Draft Decision

Transgrid Transmission Determination 2023 to 2028

Attachment 5
Capital expenditure

September 2022

Figure A.2 Transgrid's augex from 2009–10 to 2027–28

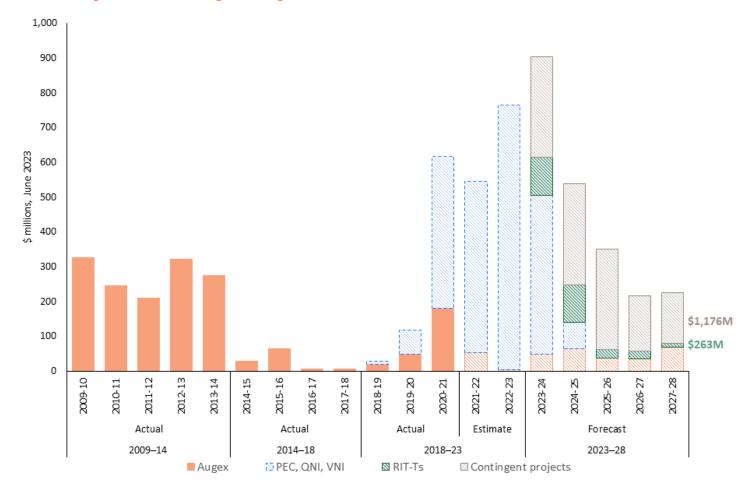
Figure A.2 above shows Transgrid's augex from 2009–28. Although Transgrid noted that its \$256.3 million augex forecast is 16% below current period augex, we consider this is not a meaningful comparison as augex is volatile from one regulatory control period to the next. This is particularly relevant as Transgrid expects to potentially undertake more capex than has been included in its proposed augex as part of contingent projects. In particular, ISP-related capex that Transgrid has identified as potentially incurring in the 2023–28 period totals approximately \$6.4 billion.

Figure A.4 Transgrid's historical and forecast recurrent ICT capex

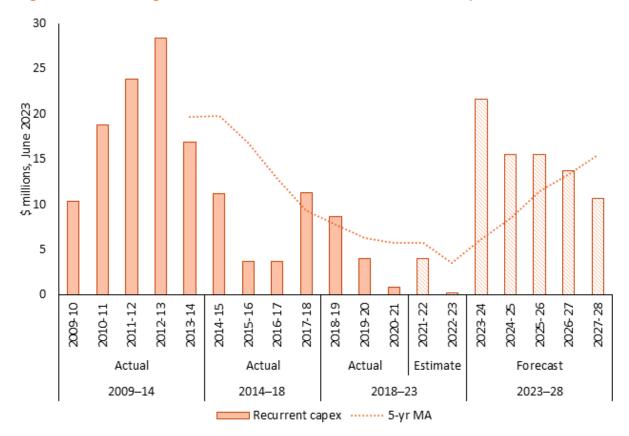
Given the higher proportion of Transgrid's non-recurrent ICT capex, we observe a decline in the five-year moving average (used to smooth the profile) of recurrent ICT capex followed by a sharp increase in 2023–28, as shown in Figure A.4. Averaging the 2009–23 recurrent capex, we find an indicative amount of \$44–53 million is expected for the forecast. Adding the proposed \$9.7 million non-recurrent ICT capex yields an indicative total ICT capex of \$54–63 million.

Figure A.6 Transgrid's historical and forecast total ICT capex profile

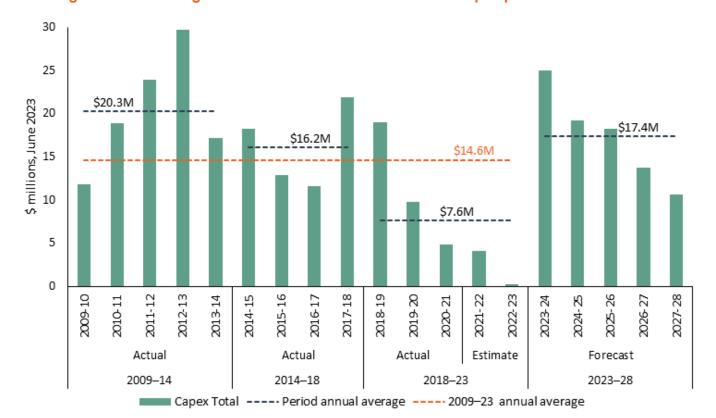
Figure A.6 illustrates Transgrid's ICT capex over time, with annual averages for each regulatory control period. We observe a significant step-up (129%) for 2023–28 compared to the ICT capex Transgrid expects to incur in 2018–23. We do not consider Transgrid has sufficiently justified a step-up of this magnitude, especially considering the consequent increase in forecast opex associated with SaaS moving from capex to opex.⁶⁷ Further, the proposed 34% forecast increase in totex (capex + opex) is not consistent with the expected efficiencies of transitioning to cloud computing services.

Figure C.4 EMCa's analysis of the preferred solution cumulative present value and NPV using four modified assumptions

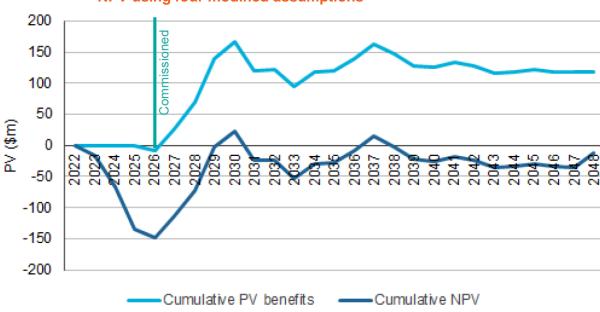
EMCa considered four sensitivities to test the net market benefit presented by Transgrid. 149 The outcomes of this sensitivity analysis suggest a negative NPV as shown in Figure C.4 below. EMCa recognises the tested sensitivities are not all independent factors but has used this test to indicate that on the balance of probabilities it is not reasonable for Transgrid to conclude that the proposed transmission line solution is NPV positive.

A key factor considered by EMCa relates to network support arrangements to relieve constraints in the short-term. EMCa considers the option of extending the network support arrangements (special protection scheme (SPS), and BESS) to cover the years when the majority of the benefit is assumed to occur, has been too readily dismissed by Transgrid. Transgrid does not consider a longer-term SPS is credible as it does not have a proponent and does not consider extending the BESS network support service beyond the assumed three years due to impracticalities of reconfiguring the BESS controls to continue providing identified benefits. EMCa considers the lack of rigorous examination of the feasibility of extending the SPS and BESS beyond the assumed timeframes leads it to conclude that the construction of a new transmission line is not justified. 151
